**Hamburg Township
Zoning Board of Appeals
Wednesday, February 10, 2021
Virtual Meeting using GoToMeeting platform**

Zoning Board of Appeals Staff Report

SUBJECT: ZBA 20-012

PROJECT: Variance application to permit the construction of a two and a half story, 2,688 square foot dwelling and an attached 990-square foot garage. The dwelling will have a 12-foot north front yard setback (25-foot front yard setback required, Section 7.6.1.).

Picture 1: Existing Single Story:

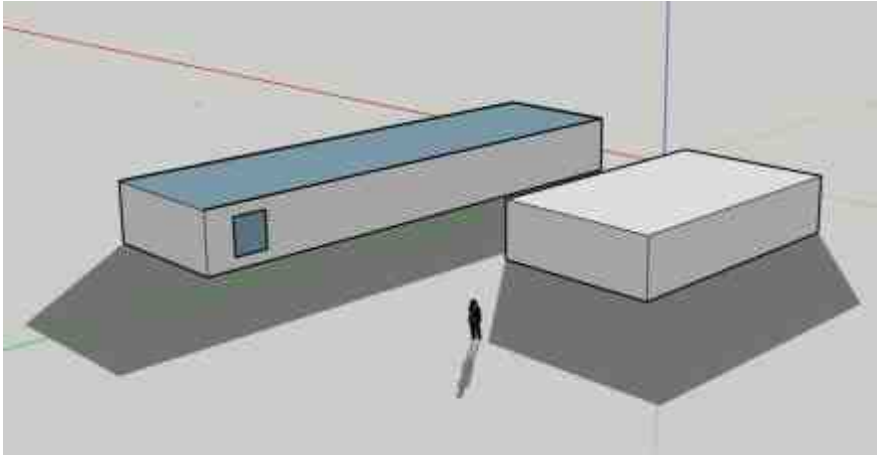
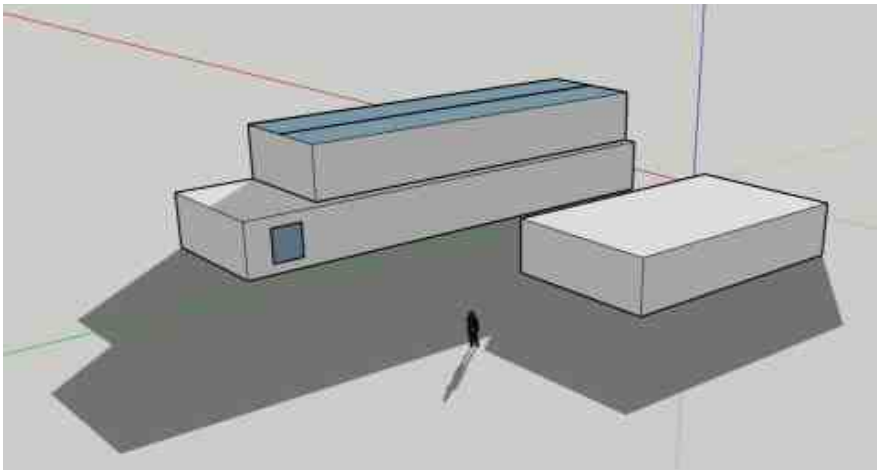
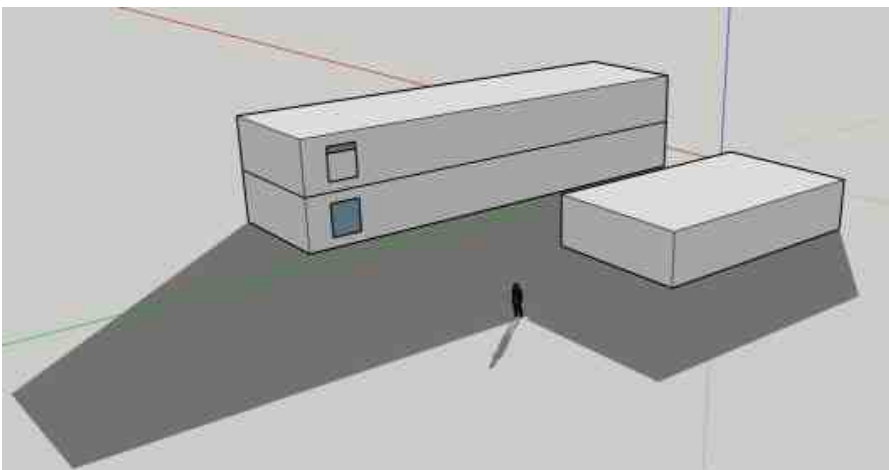
The intent of the front yard setback is to require enough space between the roadway and the structure so that structures do not loom over the street and the intent of the lake setback is to reduce the environmental impacts that a structure will have on the lake and also to reduce the visual impact that a structure would have as viewed from the lake.

The proposed structure will be 4,258 square feet, 2 1/2 stories tall and will meet the maximum height requirement. However, the ZBA should consider the sheer bulk of the structure at the proposed setbacks, not just the plan view. Because of the size and height of the proposed structure placing the structure within the required lake and front setbacks will have a greater impact of the views of the structure from both the lake and Shoreview Lane.

MORTGAGE SURVEY

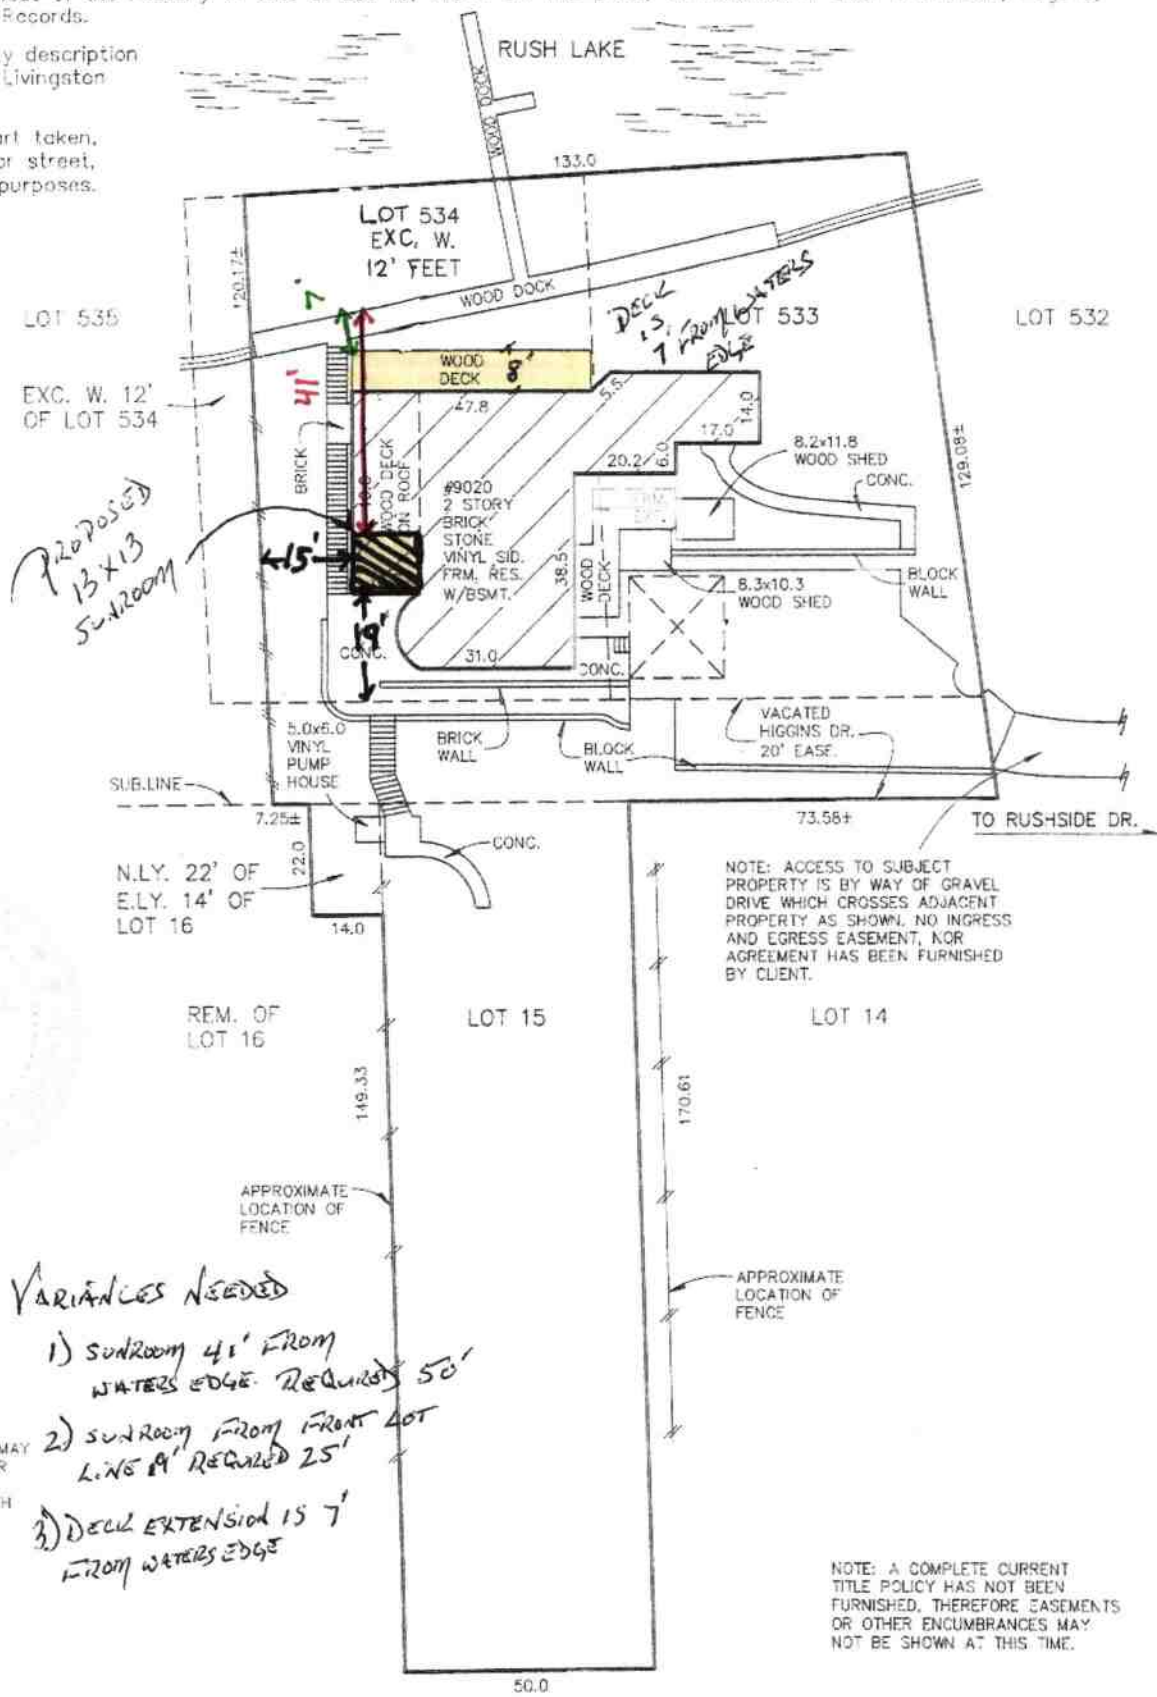
Please provide accurate site plans, including setbacks from the elevated deck, the home, and the proposed sunroom to all lot lines. the information listed in the checklist within the attached packet on pages 2 and 3.
Please also include a floor plan if the interior layout of the home has been updated.

3. The site plan did not indicate the setback distance from the water, we inspected and measured approximately 40/41 feet. This does not meet the required 50-foot setback. This was not included in the notice that was published.
